SUBJECT: January 27, 2026 HISTORIC PRESERVATION COMMISSION MEETING

STAUNTON HISTORIC PRESERVATION COMMISSION

HSF Recommendation

815 West Beverley Street

815 W. BENEVOLENT EXISTING PORCH
EAST ELEVATION TO BE SOAKED

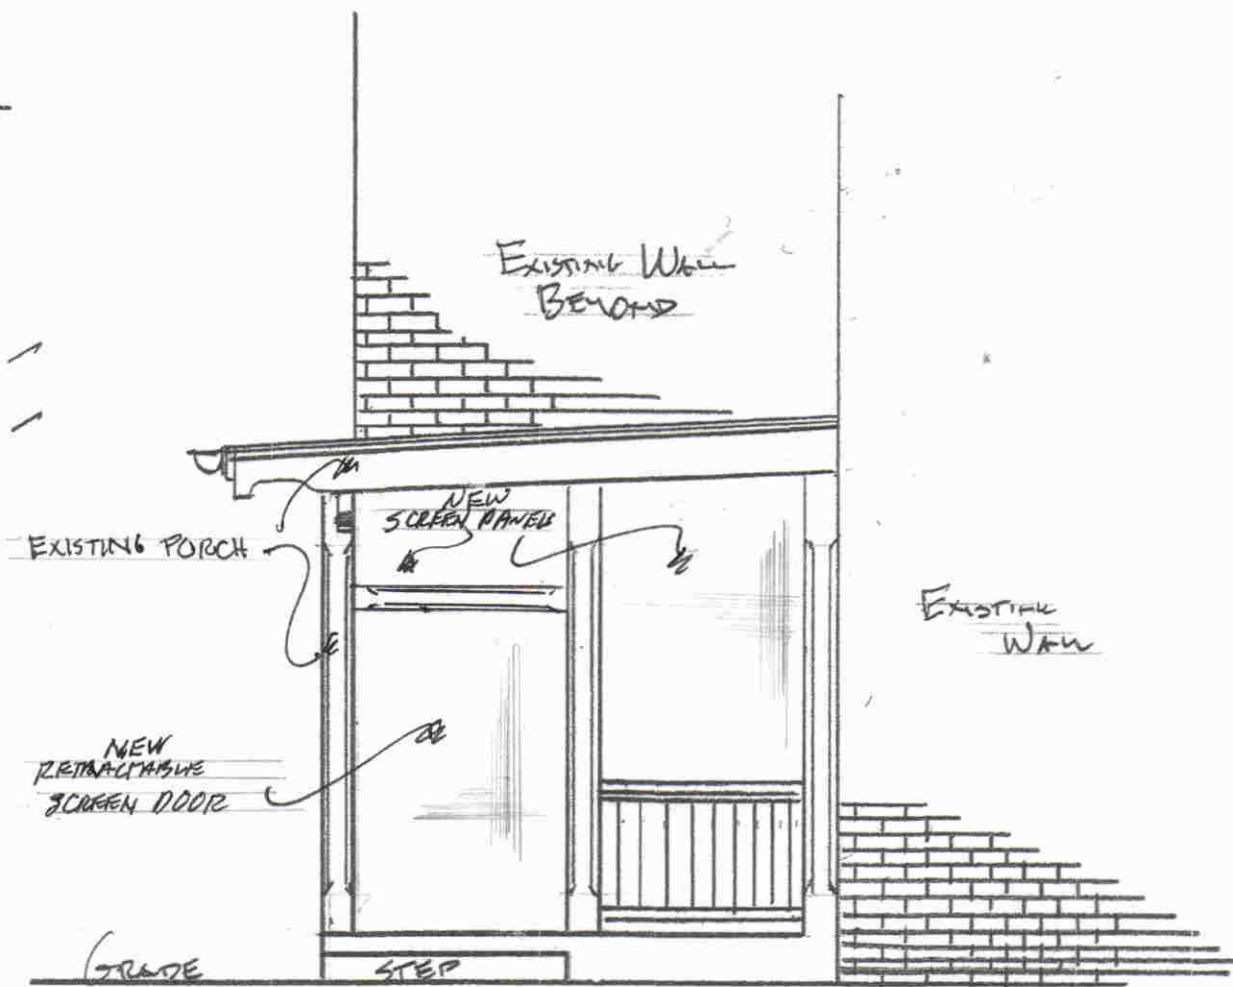
HSF Recommendation: HSF recommends the certificate of appropriateness be approved. The porch is located at the side and toward the rear of the house with limited view. The treatment does not enclose the porch and will not alter the size, scale, or materials of the porch.

Sample Motion: I move the Certificate of Appropriateness be appropriateness be approved as submitted.

Application for 815 West Beverley Street Solar Panels

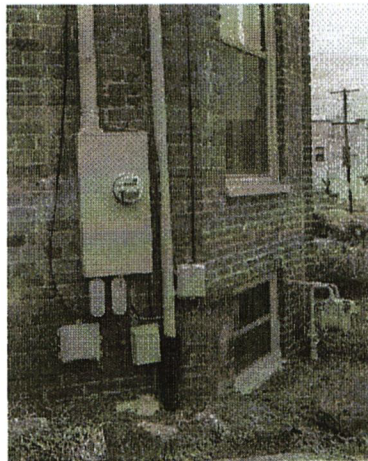
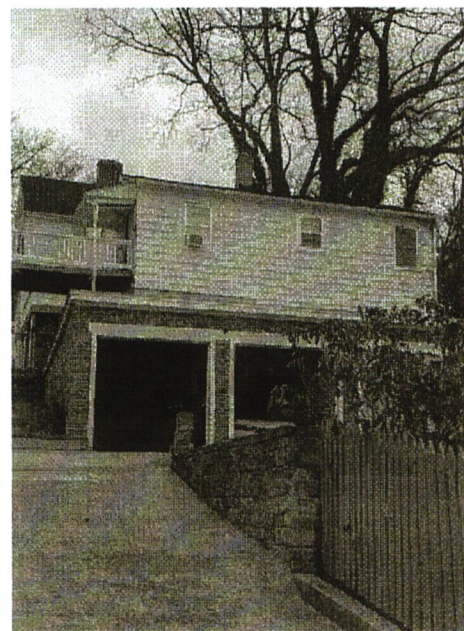
The application proposes to install a solar panel array on the rear sections of the house roof and on the garage roof.

PROPOSED EXTERIOR RENOVATIONS
for
ARCADIA PROJECT-DIXIE THEATER

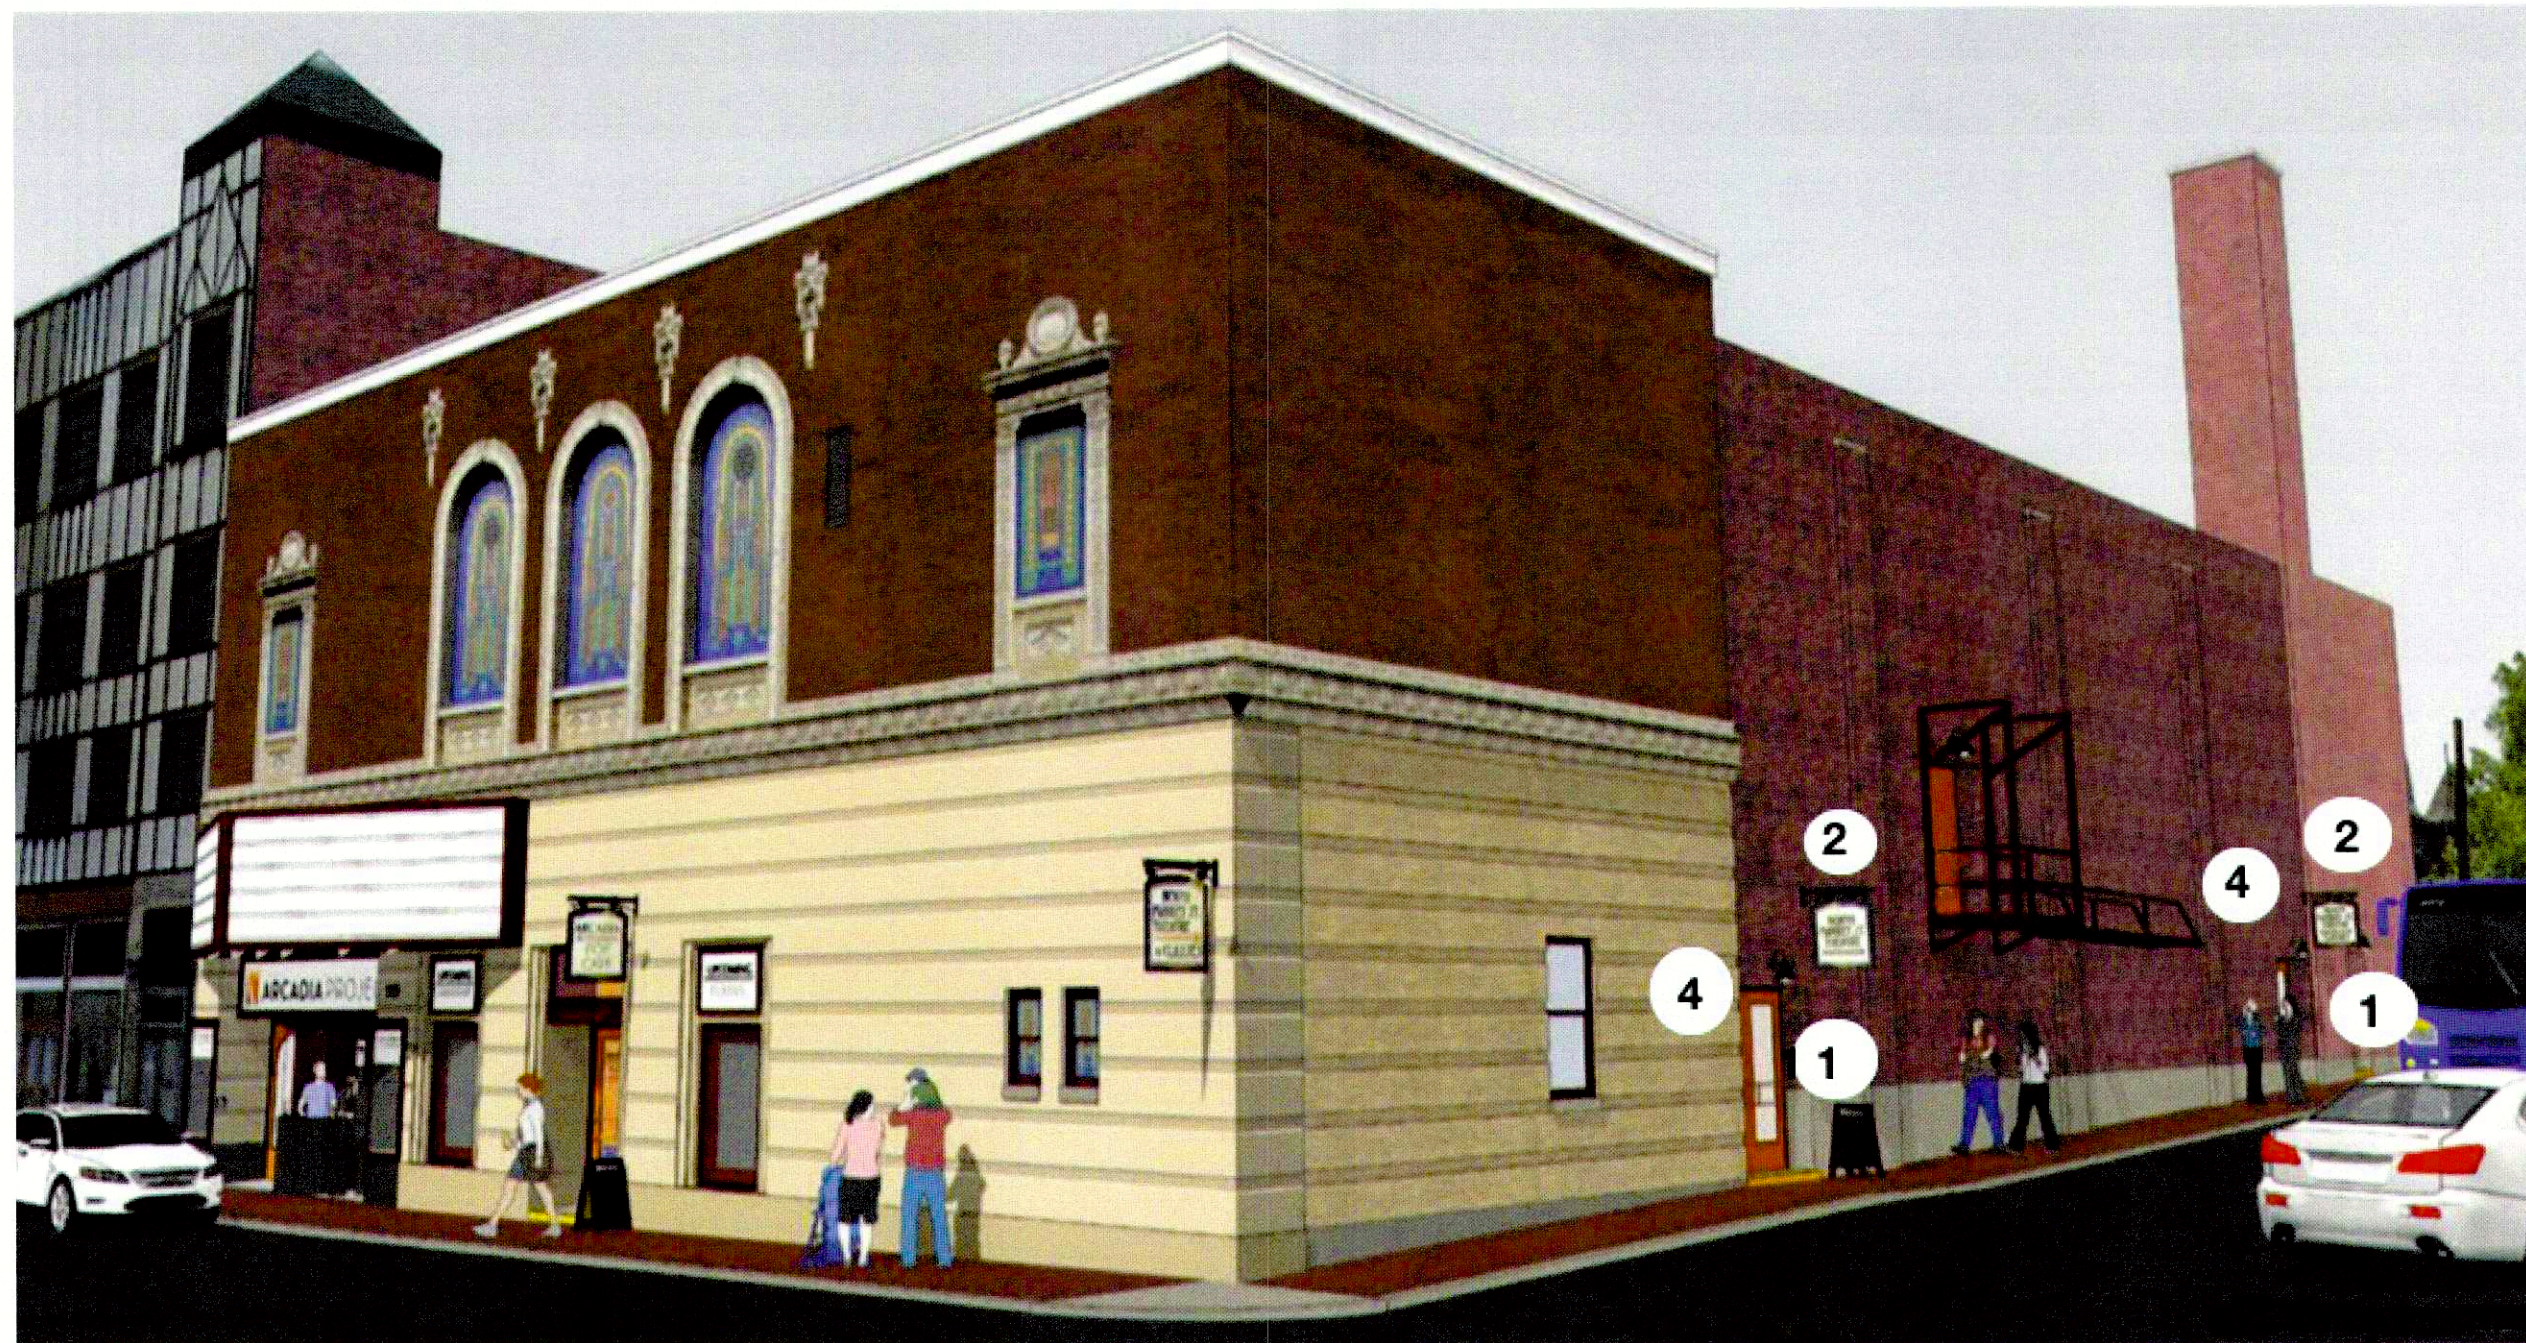
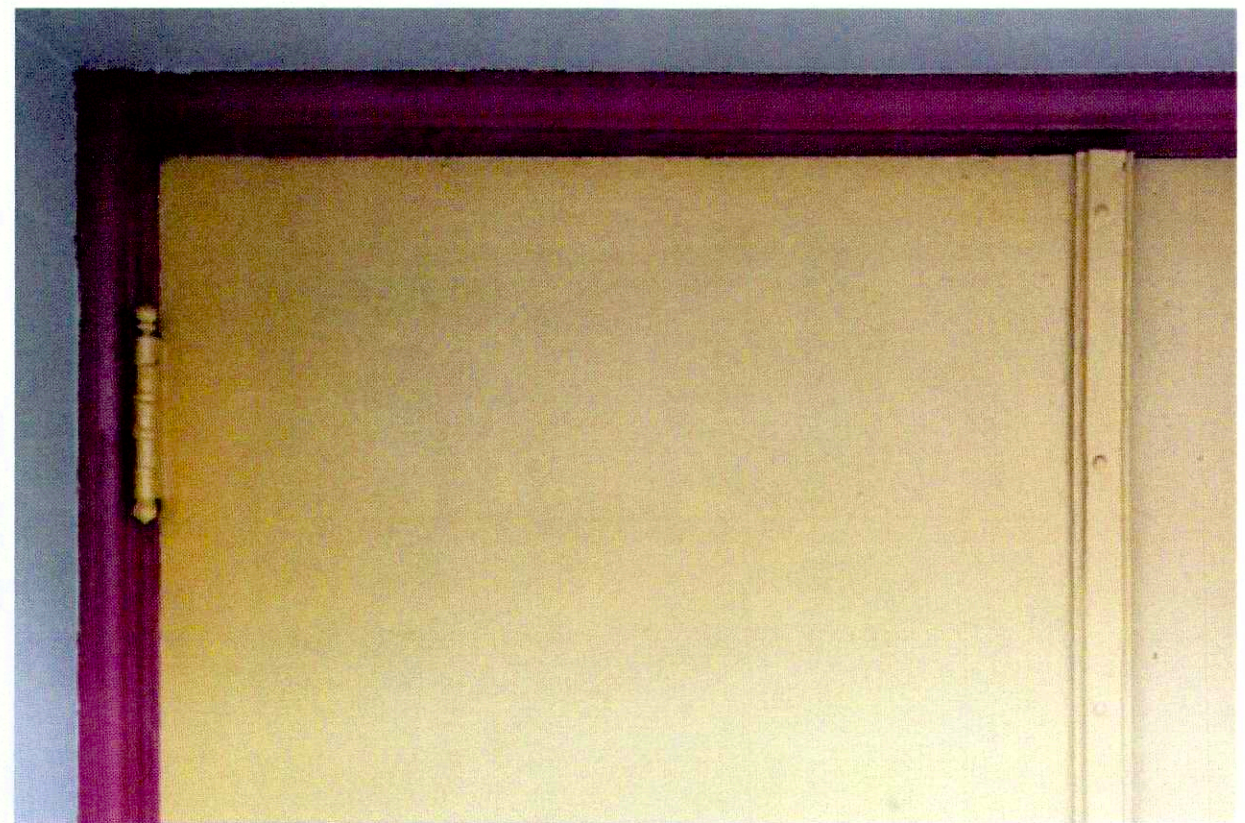
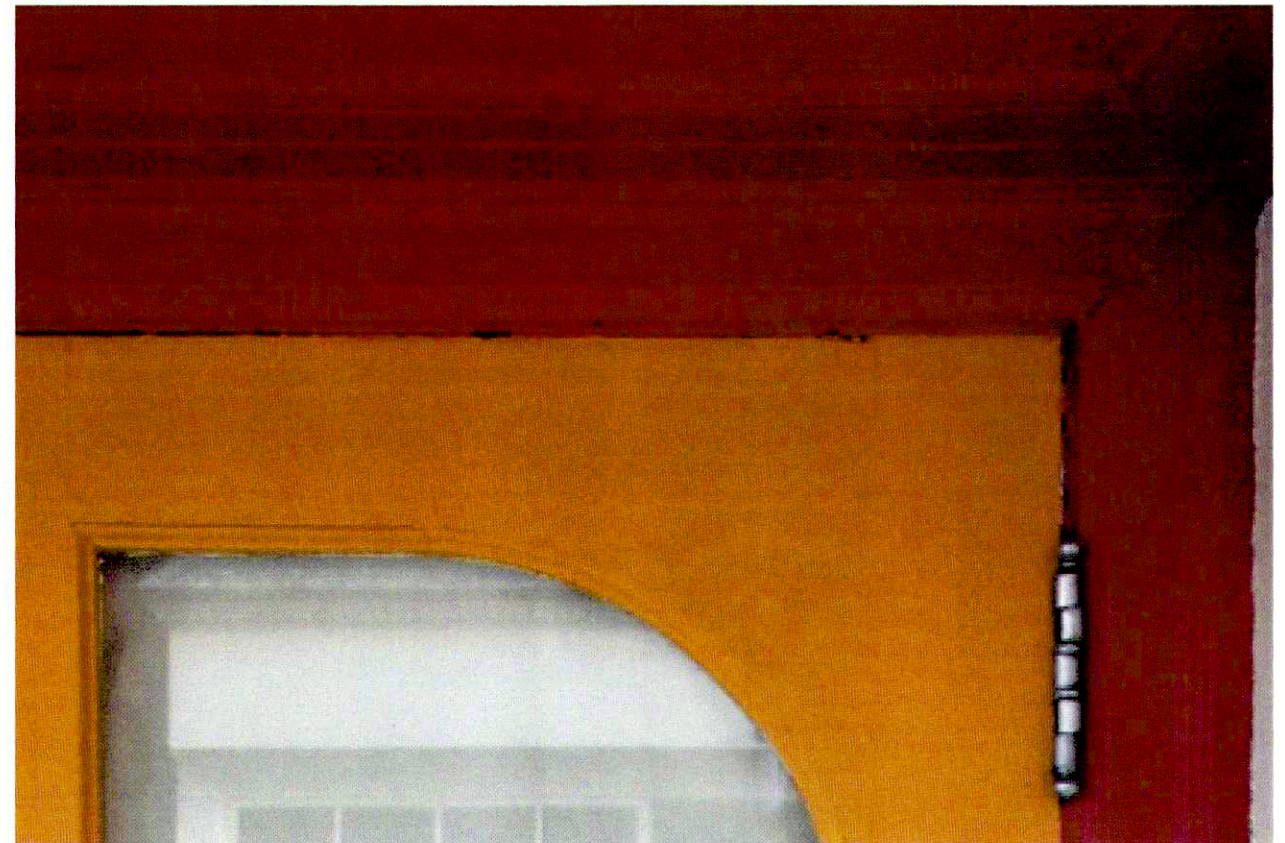
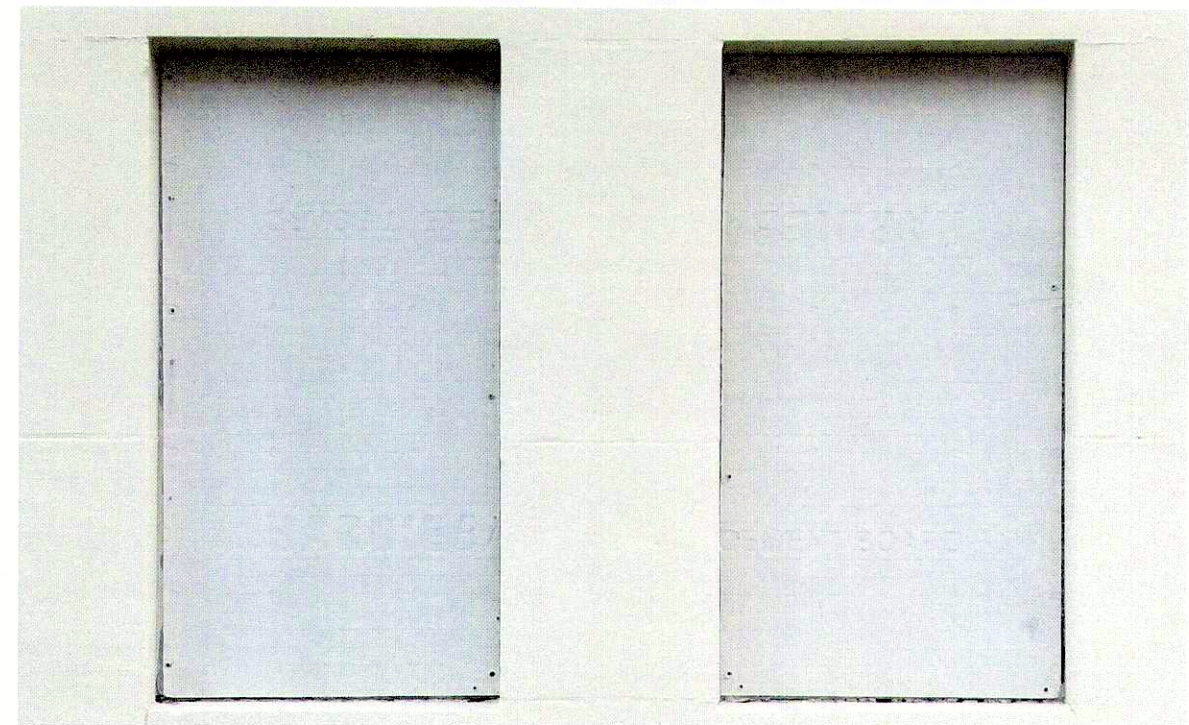
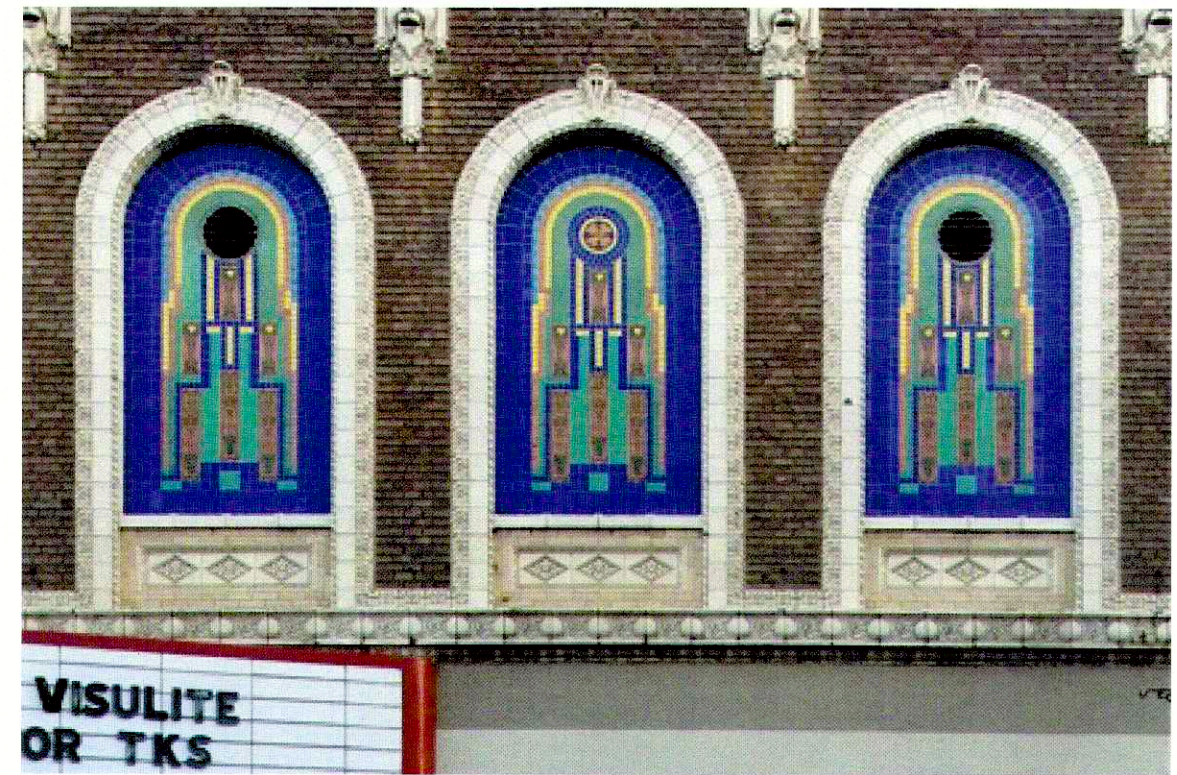
1. Replace the existing flush hollow metal exterior doors on the Beverley Street and Market Street facades with new hollow metal and full obscure glass panel doors. The metal portions shall be painted to match the color of the existing wood entry doors.

4. Replace the existing utilitarian style wall mounted light fixtures, located above the exit doors, on the Market Street facade with new shaded light fixtures in a design that is more appropriate with the design of the building and compliments the design of the signage brackets.
